From: [Michael Stephenson](#)
To: [Jump, Christine](#)
Cc: [SMITH, MARTIN L](#)
Subject: IRM Workplan Response to Comments for Building J
Date: Monday, May 05, 2014 10:19:48 AM
Attachments: [RTC Letter for Bldg J.docx](#)
[Table 1 - IAOs.pdf](#)
[Figure X - Sump Locations.pdf](#)
[Soil Pest Herb PCB Table.pdf](#)

**SUMP LOCATIONS
 CLEAN HARBORS KANSAS, LLC**

SUBJECT: RESPONSE TO COMMENTS ON DRAFT RCRA SOIL INTERIM REMEDIAL MEASURE WORK PLAN, CLEAN HARBORS WICHITA FACILITY, 2549 NEW YORK AVE, WICHITA KANSAS (RCRA ID # KSD007246846)

FIGURE X

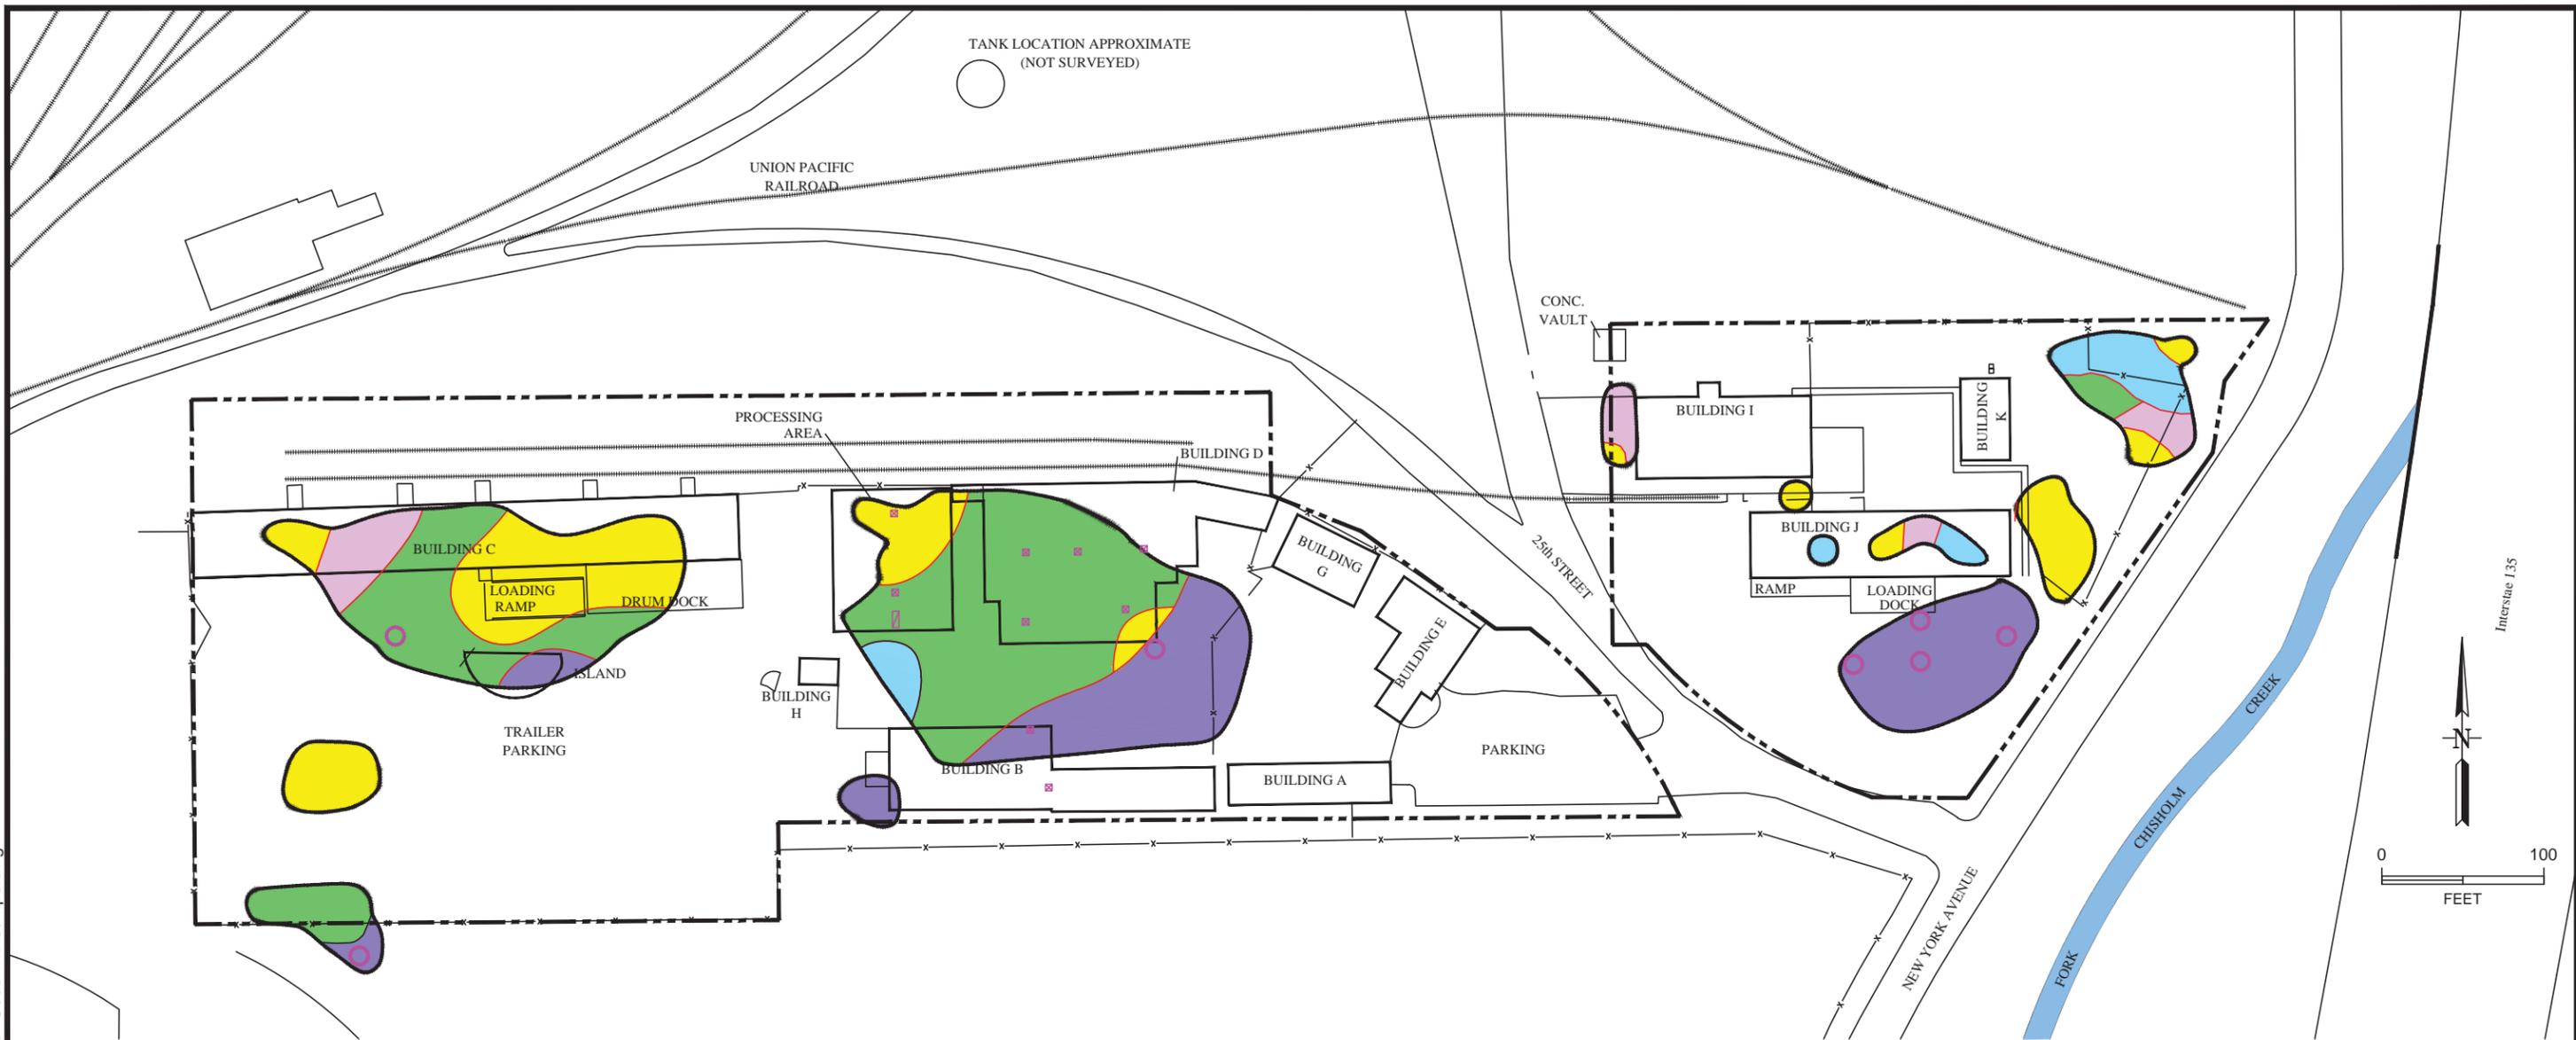
- 7. Section 3.1, page 12, bullet #6:** *The closure and partial closure plans require sampling beneath floor cracks and sumps. If there are cracks in the floor of Building J that were not addressed to the KDHE's satisfaction by sampling to date, additional sampling or floor removal may be necessary in those areas. Please note, the closure plans require analysis for everything for which the facility is permitted. The proposed closure sampling was postponed due to the presence of VOCs above the IAOs. Therefore, based on the analytical sampling results presented in the draft IRM work plan, sampling for the full suite of compounds required by the closure plan has not been performed. Please propose a sampling plan to address these concerns (see also comment 12 below)*

A cost estimate previously prepared for the Wichita facility listed the following sumps at the facility: 5 sumps located in Building D; 2 sumps located in building B; 1 sump located in Building J; 1 sump located in Building I; and 3 sumps located in the Processing Area. The Analytical data table only indicates one sump area sampled to date, in building D. Please prepare and submit a figure locating these other sumps prior to demolishing the buildings. If these sumps are in areas not currently proposed for excavation, additional sampling will be necessary after the concrete in these areas is removed to determine if excavation is required. (this is not necessary for the sump in building I).

CH Response: Because Clean Harbors is rescinding its request to close Building J, collection of closure samples beneath building J associated with any cracks will not be performed at this time. Samples collected beneath Buildings B, D and J were collected for analysis of VOCs, SVOCs, metals, pesticides, herbicides and PCBs as specified in the RFI work plan. With the exception of the pesticide, herbicide and PCB results, the IRM workplan included soil results for all of these compounds. A table of pesticide, herbicide and PCB results is included as Table 2.

The attached Figure X depicts the location of all sumps present at the facility. As shown on the figure, all of the sumps present at the facility are located within the proposed excavation limits with the exception of the sump located in the center of Building B. Because soil in the vicinity of these sumps will be excavated during implementation of this IRM, no sampling beneath these sumps will be performed. Soil beneath the sump in the center of Building B will be sampled during the course of the IRM activities to determine if any evidence of a historic release is present.
